COLORADO GEOLOGICAL SURVEY

September 19, 2017

Subject: East Vail Rezoning Rock Fall Study Review - Revised
Eagle, CO; CGS Unique No. EA-18-0002

Figure 1

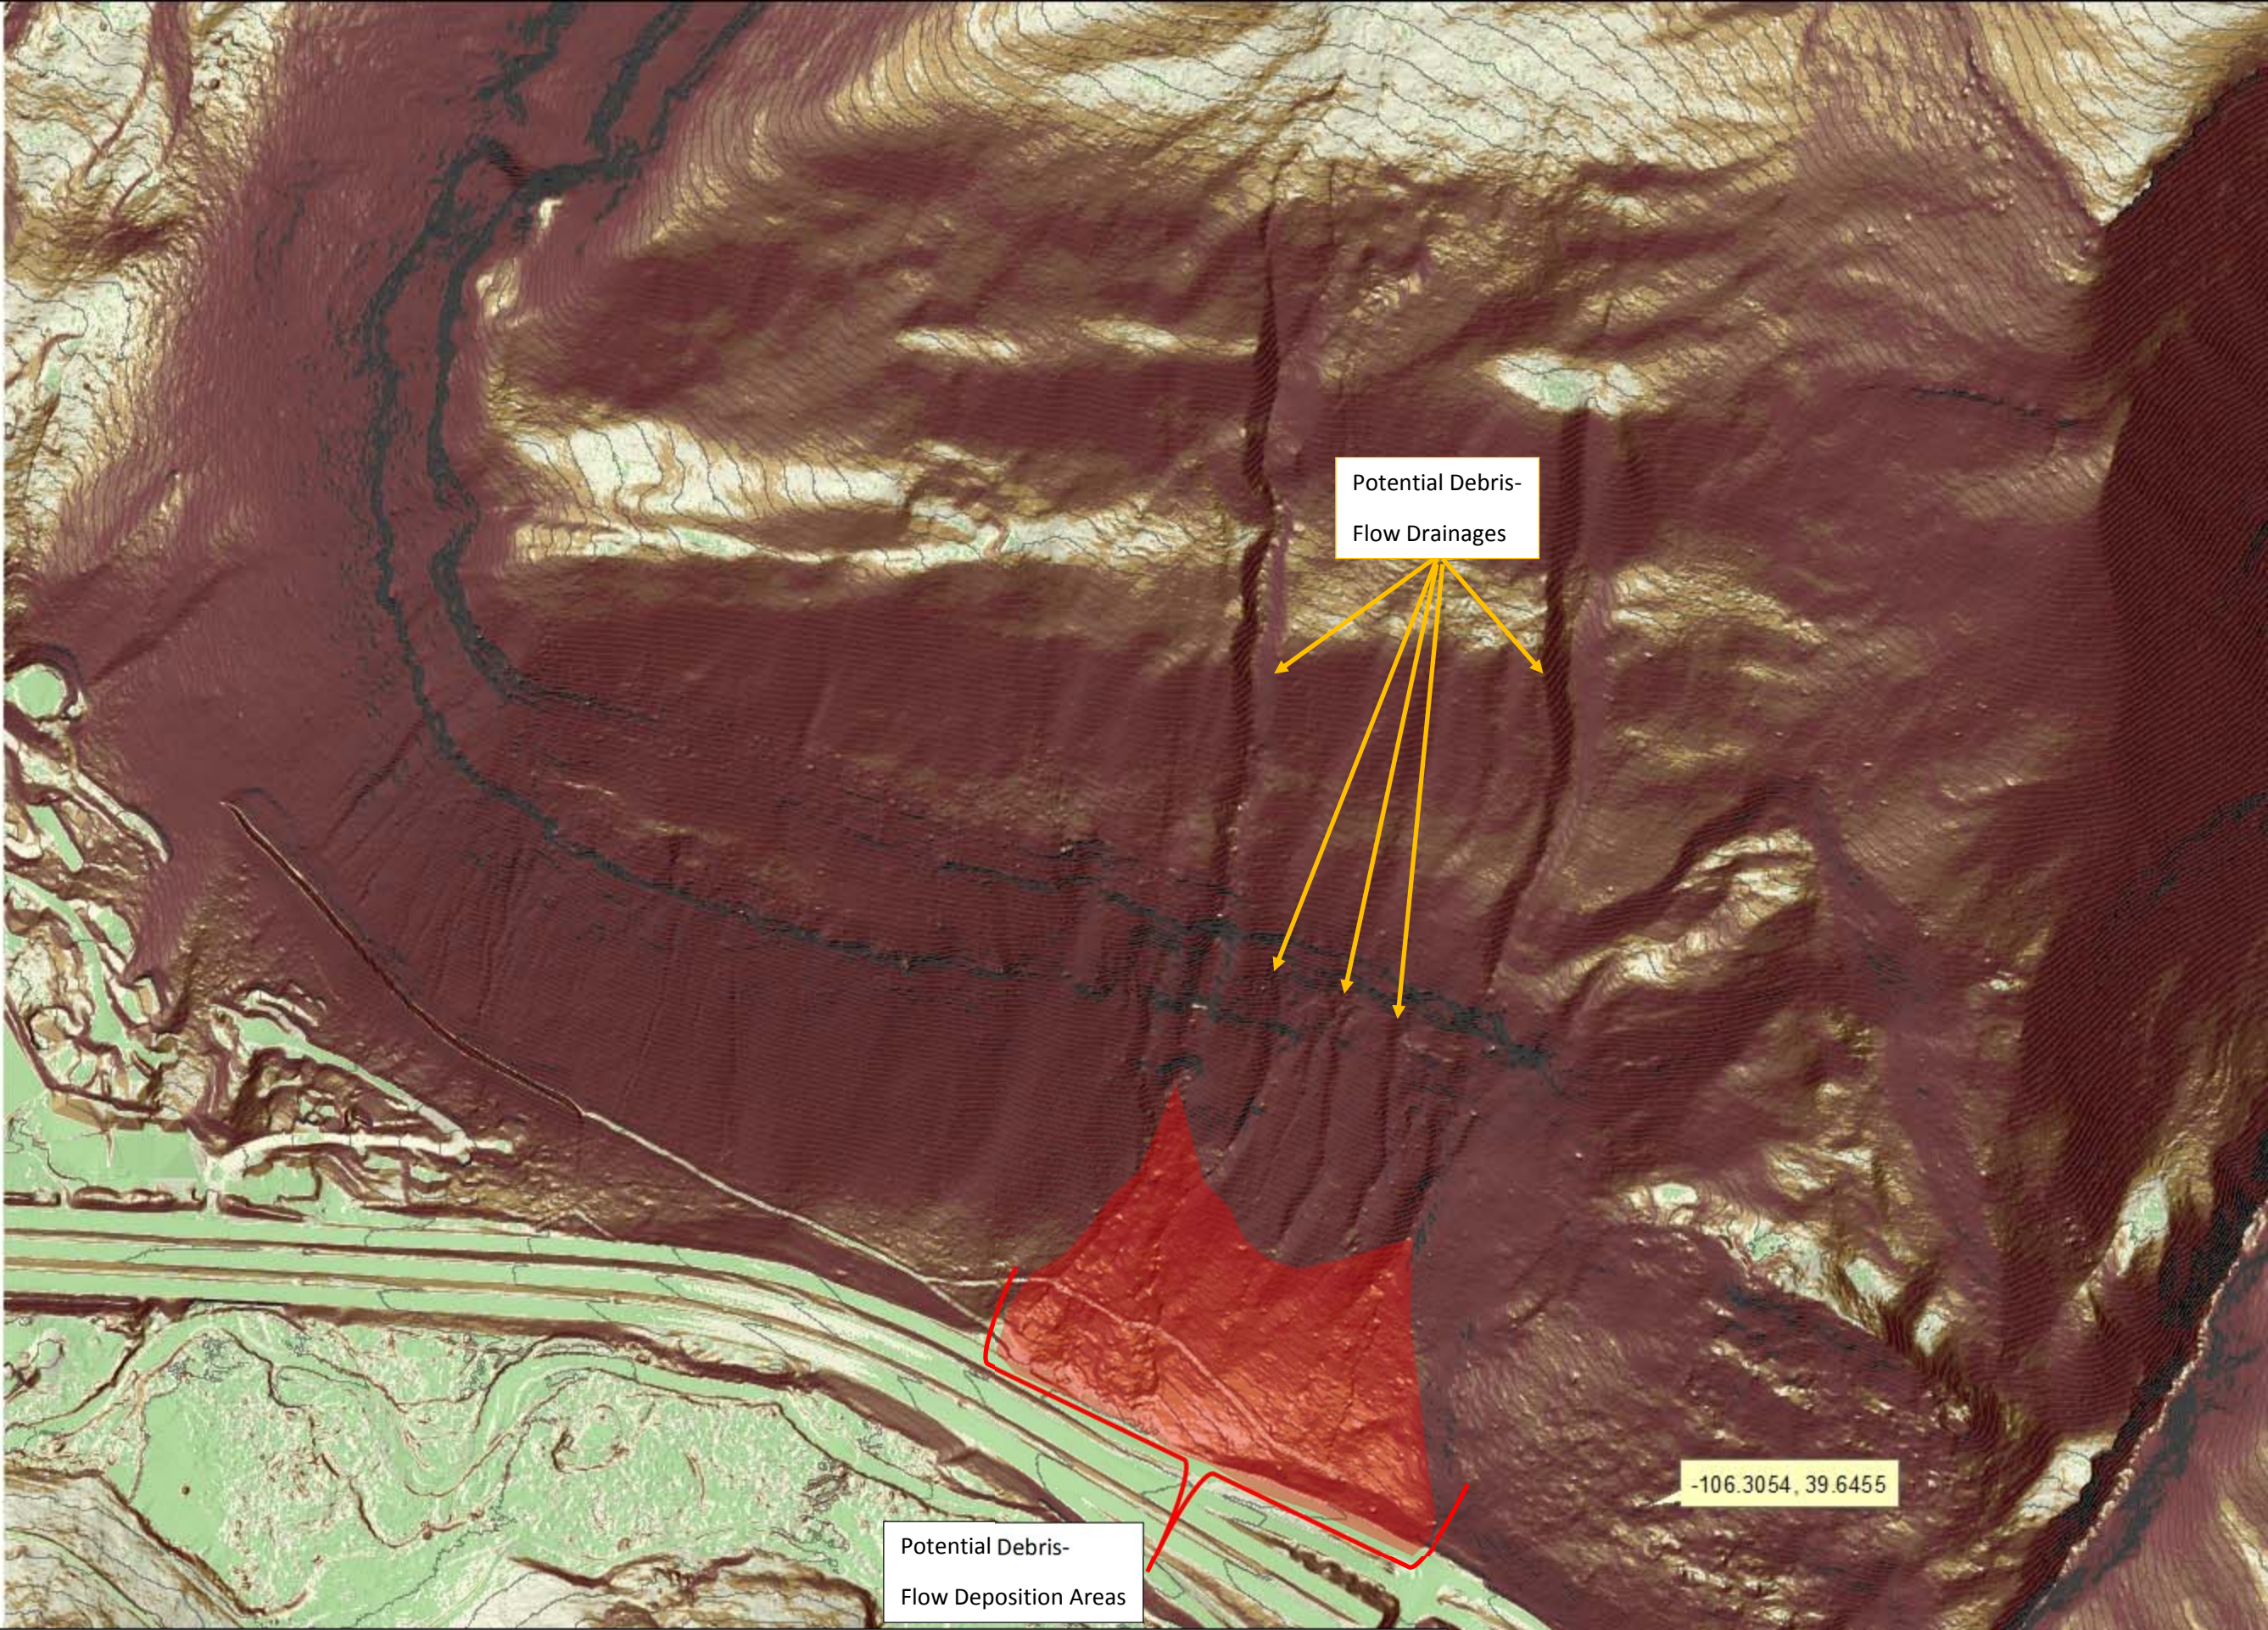
CGS agrees with the “Debris Flow Considerations” discussed on Page 30 of the Cesare report. Based on our desktop review, it is CGS’s opinion that the western portion of the site is exposed to potential debris flows, especially beneath the incised drainages highlighted in attached Figure 1. Depending on local conditions, engineered debris-flow mitigation may be possible at the subject property. However, because debris-flow hazards have not been studied at this site, and because CGS has not seen any specific development plans showing size or placement of buildings, CGS cannot comment on the potential feasibility or effectiveness of debris-flow mitigation at this time. If the Town approves rezoning, CGS recommends that the Town require completion of a debris-flow hazard analysis and design of any necessary mitigation (including preparation of an inspection, maintenance, and repair manual) prior to final Development Plan approval to ensure that the proposed mitigation will provide adequate protection and can be maintained to ensure future performance. CGS requests the opportunity to review and comment on any such hazard analysis and/or mitigation design.

Figure 2

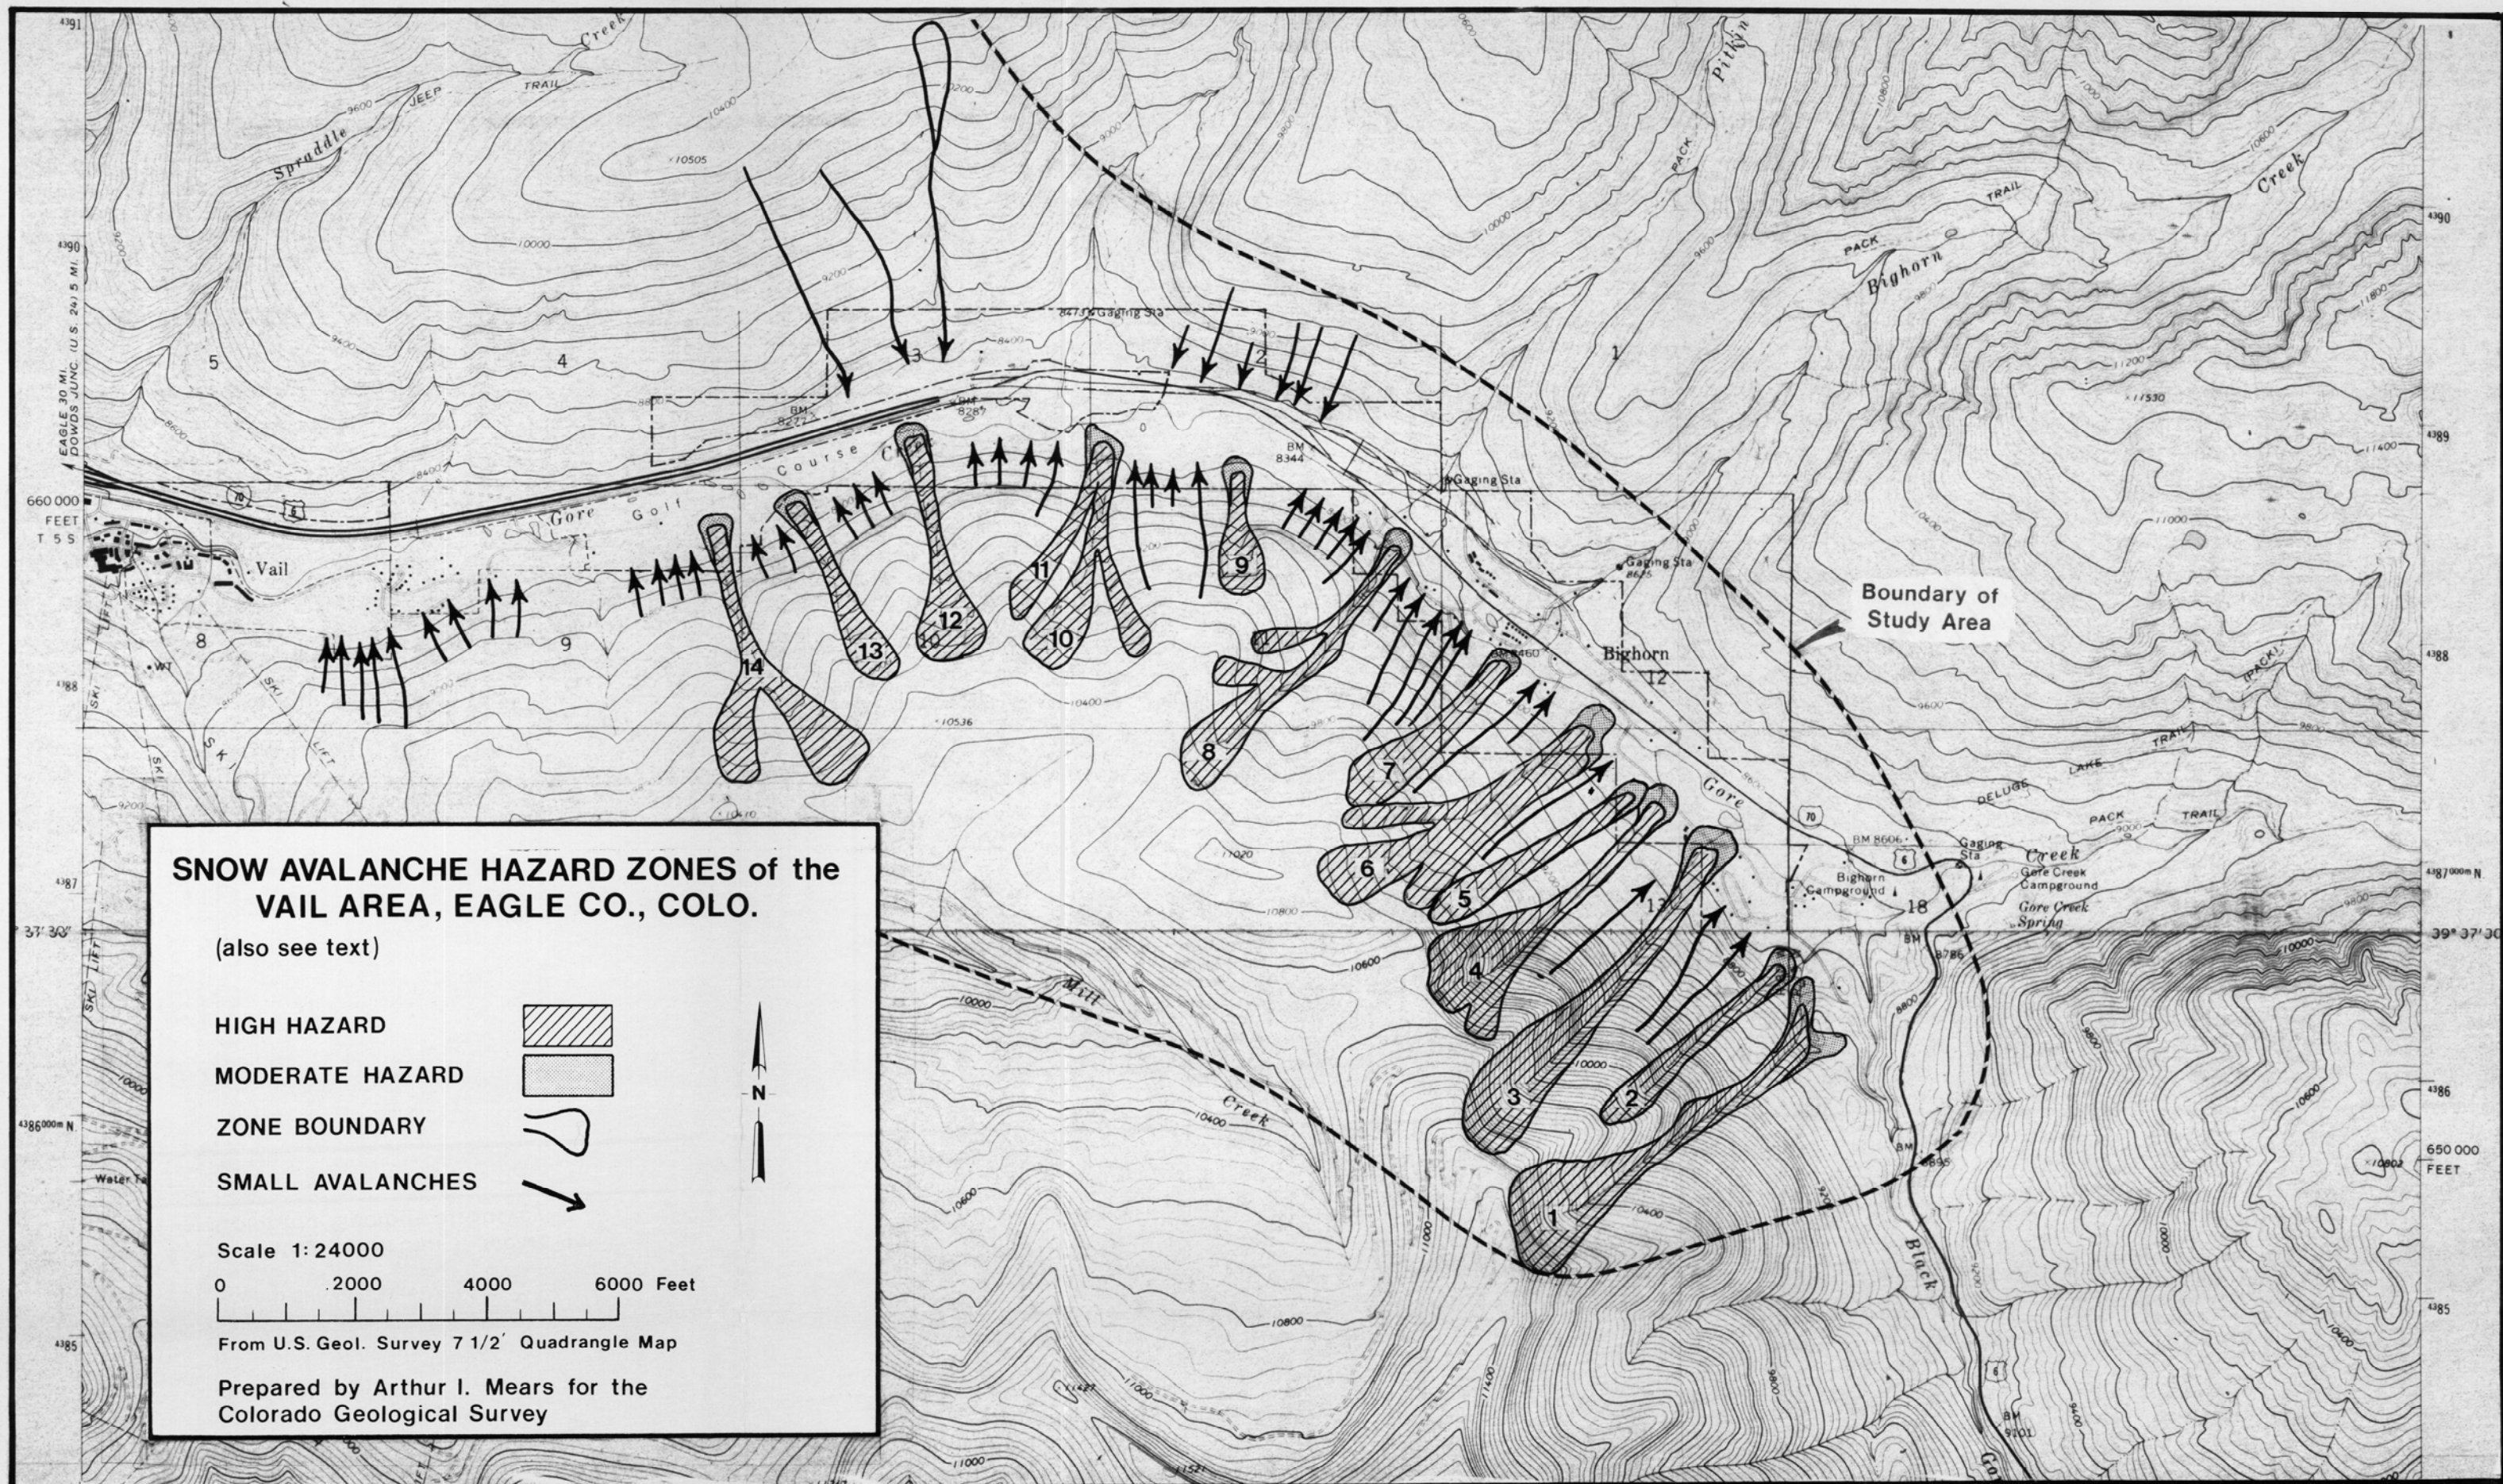
The subject property is included in snow-avalanche hazard maps for the Vail valley that were initially prepared for a CGS Open-File report in 1975, and were subsequently reproduced in CGS Special Publication 7 “Colorado Snow-Avalanche Area Studies and Guidelines for Avalanche-Hazard Planning”. Attached Figure 2 shows the 1975 map for the Vail area, which identifies “small avalanches” along the hillslope to the west of, and possibly including, the western portion of the subject site. As described in the map documentation, small avalanche areas are “not wide enough to be accurately displayed at the mapping scale of 1:24,000, so they are indicated as arrows. Although they appear small at this scale, they can also be very destructive.” Because it is not possible to rule out snow avalanche hazards to the subject property at this map scale, and because it does not appear that avalanche hazards have been specifically evaluated for the subject site, CGS recommends that the Town require completion of an avalanche hazard analysis and design of any necessary mitigation prior to final Development Plan approval to ensure that the proposed mitigation will provide adequate protection and can be maintained to ensure future performance. CGS recommends that any such hazard analysis and/or mitigation design be reviewed by the Colorado Avalanche Information Center.
